# **Proposal for Supplement 15 to the 11 series of amendments to UN Regulation No. 13 (Heavy vehicle braking)**

#### Submitted by the Working Party on Brakes and Running Gear\*

## Supplement 15 to the 11 series of amendments to UN Regulation No. 13 (Heavy vehicle braking)

Annex 12, Appendix 1, Figure 5A, amend to read:

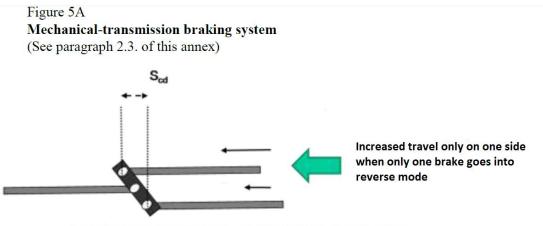
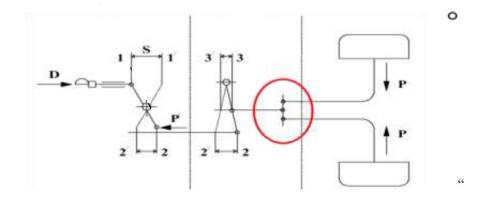
Paragraph 2.3.12. (former), amend to read and renumber:

"2.3.10. s<sub>cd</sub> Maximum differential travel that the compensator is capable to accommodate, due to its geometric and constructive properties, when only one brake operates in the forward direction and the other in reverse direction, while allowing equal tension in both cables/rods.

(See Figure 5A of appendix 1)"

"8.1.2. Drawing details are to be provided to demonstrate that the compensator articulation is sufficient to ensure equal cable tension is applied to each of the rear cables. The compensator needs to have sufficient distance across the width to facilitate the differential travels left to right. The jaws of the yokes also need to be deep enough relative to their width to make sure that they do not prevent articulation when the compensator is at an angle.

Differential travel at compensator (s<sub>cd</sub>) shall be derived from:

$S_{cd} \geq 1.2 \bullet S_r"$

Compensator geometrie allows equal tension in both rear cables
